**HERITAGE ADDENDUM  
(SD 17\_8665)**

**MERCANTILE HOTEL**

**25-27 GEORGE STREET,  
THE ROCKS 2000**

Urbis has been engaged by Welsh & Major to prepare the following heritage addendum pertinent to the refurbishment works and rooftop terrace proposed at the Mercantile Hotel, The Rocks (SSD 17\_8665).

Figure 8 – Proposed second floor services plan

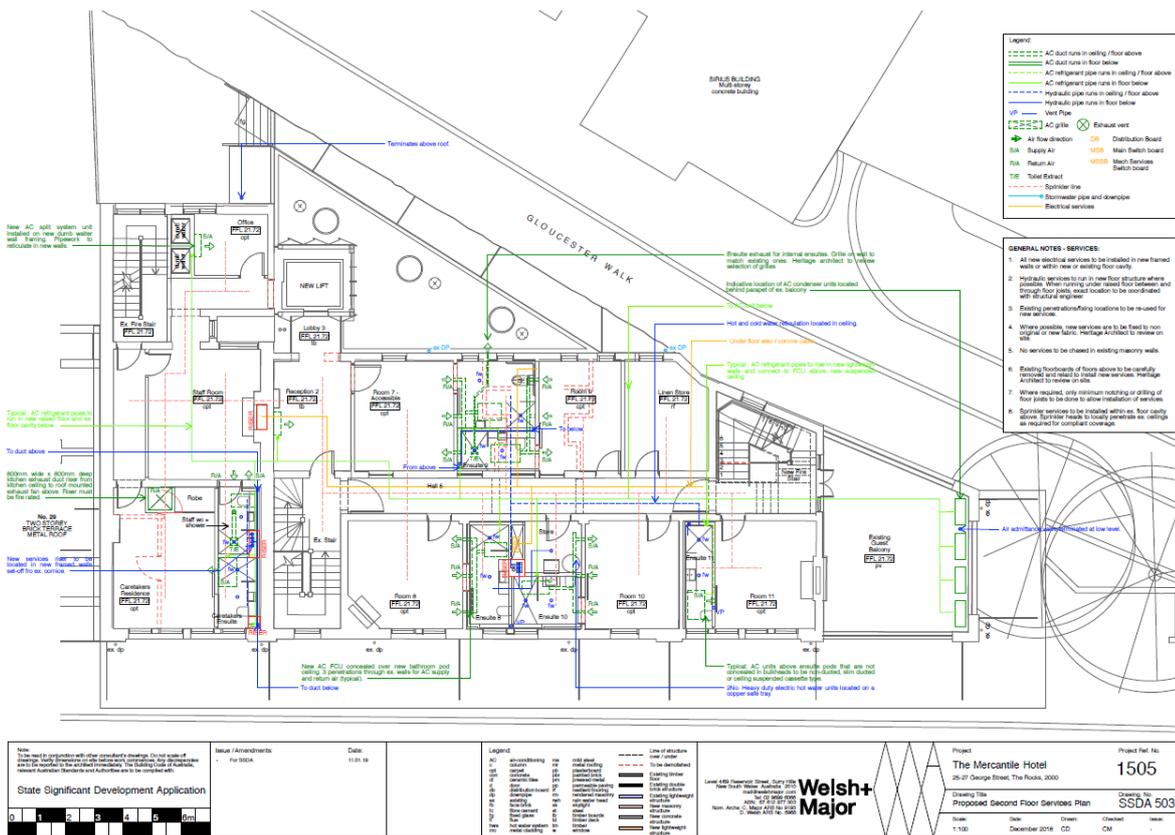
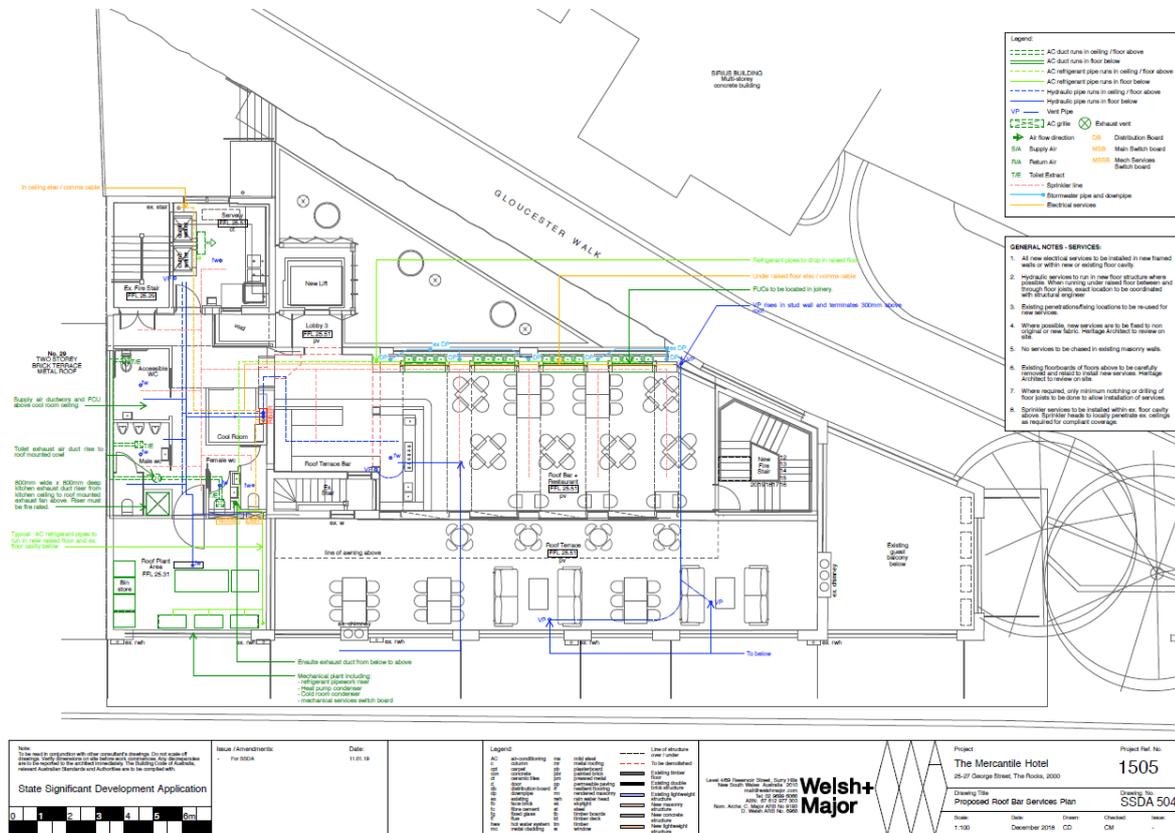
*Details have not been submitted, and only an indicative location and size of the exhaust is shown on the submitted drawings. Details of new kitchen mechanical exhaust and associated ducting should be developed in consultation with the applicant's heritage consultant with the aim of minimising visual and physical heritage impacts. These details should be submitted for consideration prior to determination of this application.*

*Provide further information in relation to the provision of services, including mechanical, electrical and hydraulic, stormwater drainage, communications and data fixings, fire separation and acoustic separation measures, new plumbing and mechanical exhausts, in order to determine the extent of heritage impacts. This shall include information on removal of existing services and provision of proposed services, including any proposed fire upgrades and services being introduced onto the roof.*

The Heritage Impact Statement advises that timber floor boards will be lifted to install services. This solution is reasonable only when it is used sparingly. There is concern that the extensive reticulation of new services will adversely affect the floors particularly when the floors feature old tongue and groove boards which are likely to split when lifted. Therefore, the extent of opening up services work affecting the floors should be shown on the general arrangement plans.

In preparing this response, Urbis Heritage has been provided with the following plans by Welsh + Major. The plans have been amended to include detailed sections of the proposal wet areas, ensuites, kitchen, and the new bar. A detailed services plan for all floors has also been included for this submission and has informed this response to submissions.

The services drawings included as part of this updated package have been included overleaf for reference. The full-size plans accompanying this response should be consulted for any details.

Figure 13 – Section C, note the installation of AC units in void between pod and extant ceiling

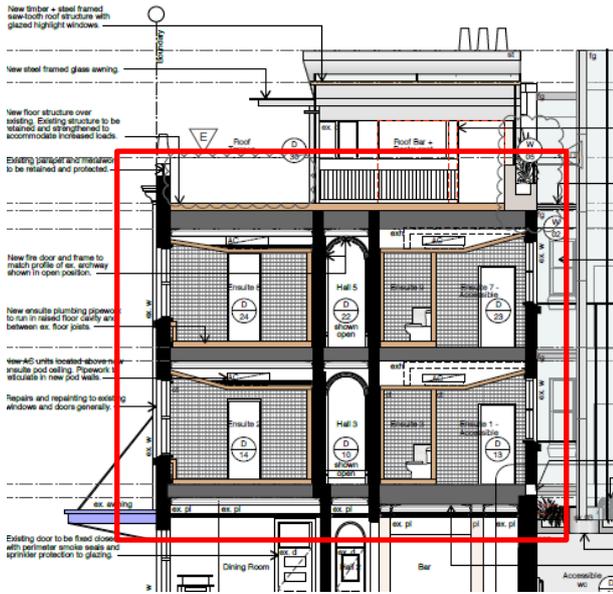
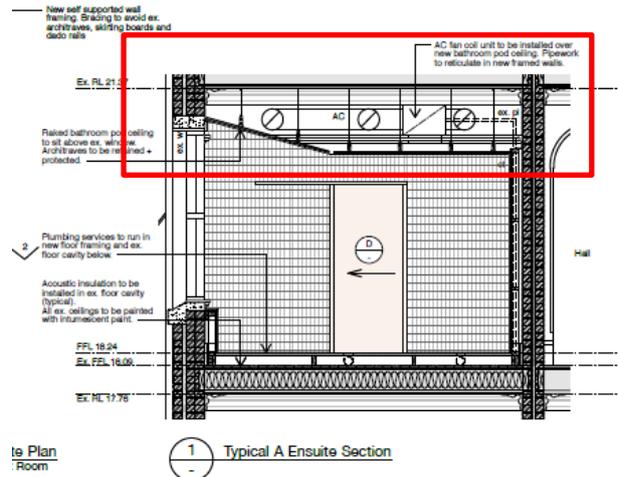
The Heritage Impact Statement (p. 71) advises that the ensuites will be inserted as pods. There is concern that the Heritage Impact Statement underestimates the actual physical impacts of the structural work and services. Therefore, detailed sections of the proposal wet areas, ensuites, kitchen, new bars should be requested to show how the new false walls, floors, ceilings and fitouts will be constructed, supported and stiffened including their interface and impact on the existing floors, existing timber joinery, skirtings, doors and windows, their architraves sills etc. and any plaster decoration.

The proposed air-conditioning system is an external compressor and internal air handling unit with reticulation pipes only within identified service runs, not ducted. The air-conditioning units would be installed above the ensuite pods with outlet and return air servicing two rooms per pod installation. The proposed penetrations have been assessed as acceptable from a heritage perspective. The installation of air-conditioning units is required to update the accommodation rooms at the site in line with expectations of contemporary patrons and to facilitate the ongoing historic use and occupation as accommodation rooms. As the proposal seeks the retention of the accommodation rooms located at site, this intervention has been assessed as acceptable from a heritage perspective.

Figure 17 – Extract of floor plans with a focus on the ground floor bar area

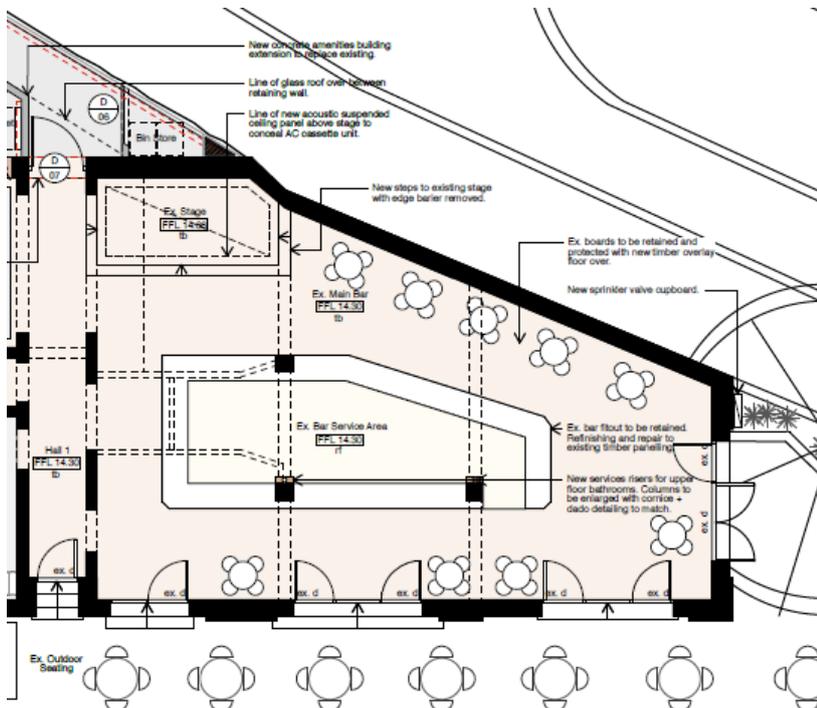
- *Proposed changes to the ground floor main bar and how this will retain and enhance the existing bar character.*

- *Proposed changes to the ground floor main bar and how this is retaining/enhancing the existing bar character and atmosphere.*

As discussed in Section 2.1 of this report, the proposed changes to the ground floor bar area (refer to Figure 17) would include:

- Existing bar fit out is to be retained, with refinishing and repair to timber panelling.
- Existing floor boards to be retained and protected with new timber overlay floor installed over.

The proposed works to the ground floor main bar have been designed to retain and enhance the significance of this central area in the building. The extant floor boards are to be retained and protected, it is proposed that a new timber overlay is installed over this element. The retention and protection of the extant timber flooring has been assessed as a positive heritage outcome. This fabric would be retained and protected, and would allow for an updated floor finish in a heavily trafficked location. It is proposed to retain, refurbish and

Figure 18 – Section showing floor levels hatched in orange and highlighted in red)

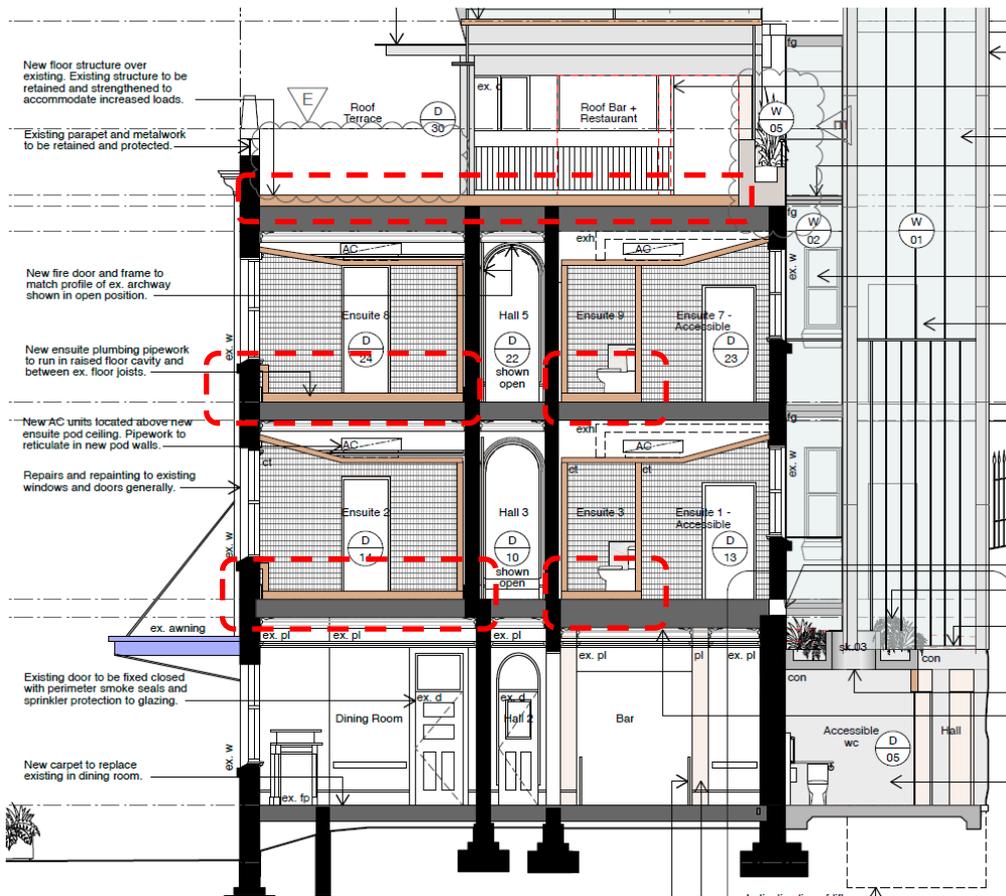
*Information should be submitted to show how the roof levels, roof floor structure, stormwater drainage and trafficable surfaces will be resolved, taking into account structural and code compliance, the existing floor levels and the outdoor terrace.*

Refer further to the updated architectural package showing detailed resolution of all floor levels and integration of new services that has been resolved in detail in collaboration and based in the advice of Urbis Heritage (heritage consultant/heritage architect). It is understood that the proposed levels have been resolved remain largely the same as the existing internally generally. Where new bathroom ensuites are located a new floor structure (set up) is installed to allow required falls and servicing to be located without any change to the existing floor structure and minimal (pipe penetration only) intervention to the existing floor making them largely reversible. Externally the roof level which is wholly obscured externally by parapet walls consists of a new floating trafficable surface that sits on top of the existing to facilitate the existing drainage system to be retained and minimal intervention. These works have been assessed to be acceptable from a heritage perspective with minimal impact to fabric of lower significance being floors (currently carpeted)

Figure 20 – Proposed finishes schedule

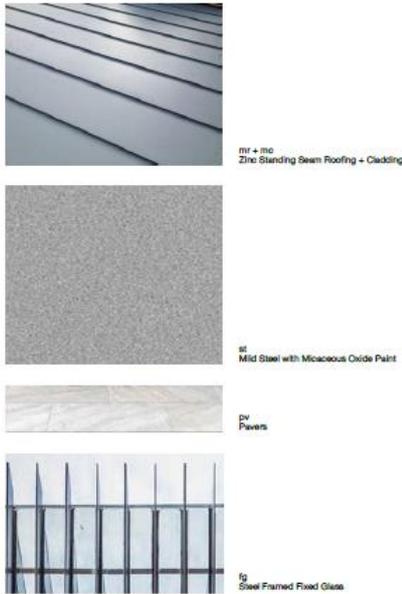
*Information provided on the proposed materials and finishes is inadequate, particularly given the building is a heritage item. A full schedule of materials, finishes and colours, keyed to elevations is required.*

- *Proposed materials and colours and appropriateness to the heritage character of the interior and exterior of the buildings.*

*Highly reflective external surfaces, large areas of unshaded glass and bright white finishes should be avoided. External colours should be subdued and take inspiration from the Mercantile Hotel's existing materials and colours. This is to minimise the visual impact of the alterations on the Mercantile Hotel's character setting and significant views.*

As discussed in Section 2.1 of this report, the proposed materials and finishes (refer to Figure 20) would include the following:

- Zinc standing seam roofing and cladding;
- Steel with a mid-grey micaceous oxide paint;
- Pavers with a neutral cream finish; and
- Steel framed fixed glass.

The proposed materials and finishes has been assessed as sympathetic to the heritage significance of the site. The finishes would be clearly discernible as contemporary ensuring that the proposed new works would be clearly discernible as such. The proposed finishes would be neutral and recessive in tone as well as utilising a heritage pallet where appropriate and would in no way compete with or overwhelm the established heritage qualities of the site, proximate heritage items or the Rocks Heritage Conservation Area.

Figure 22 – Extract of architectural plan with proposed placement and form of signage

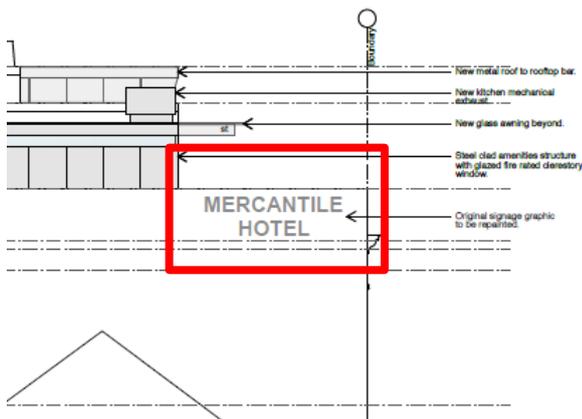
*Provide detailed plans and drawings of the proposed signage, including colour, materials and dimensions, and an assessment against the relevant provisions of the Sydney Development Control Plan 2012.*

- *Proposed signage and heritage impacts.*

It is proposed that the Mercantile Hotel signage graphic is restored. The 'Mercantile Hotel' signage would be painted on the existing southern masonry wall. There is historical precedent for this signage and the reinstatement of this feature would have a positive heritage impact on the significance of the site.
